2004 Ford Mustang V8-4.6L SOHC VIN X

A/C - INSTRUMENT PANEL VENTS RATTLE

04-5-3

03/22/04

Figure 1

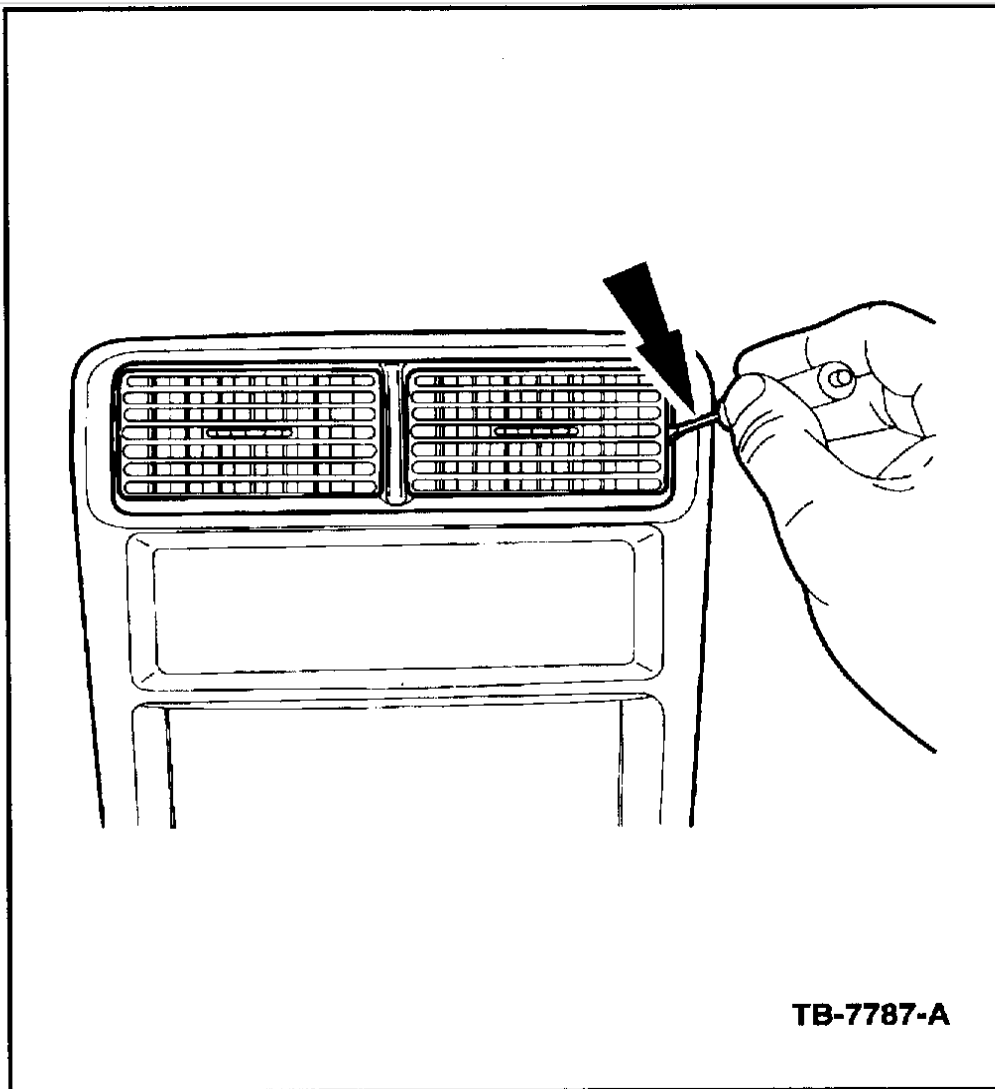
Some 2001-2004 Mustang vehicles may exhibit climate control panel vents (barrel vent) with vanes that are difficult to adjust, and/or may make a rattling type noise. This may be due to detachment of the air vanes from the pilot holes in the vent housing.

2. Remove the vent by prying it away with a flat screwdriver (Figure 1).

Figure 2

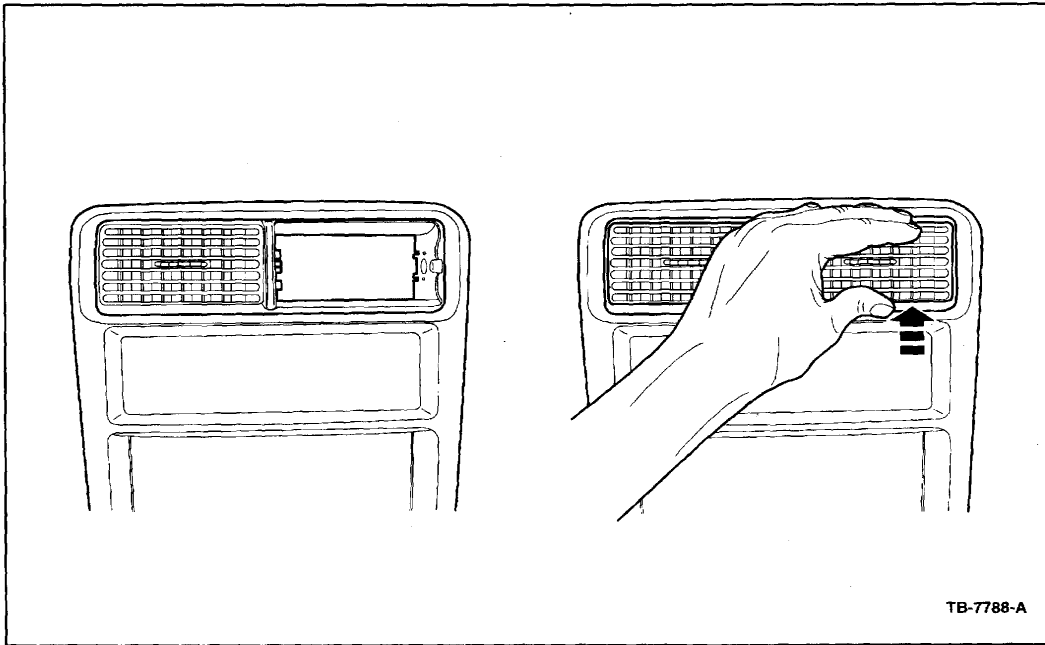
To service, install revised vent (3R3Z-19893-AB).

3. Install the revised vent by pressing the new vent into place (Figure 2).
4. Repeat Steps 1-3 as needed.
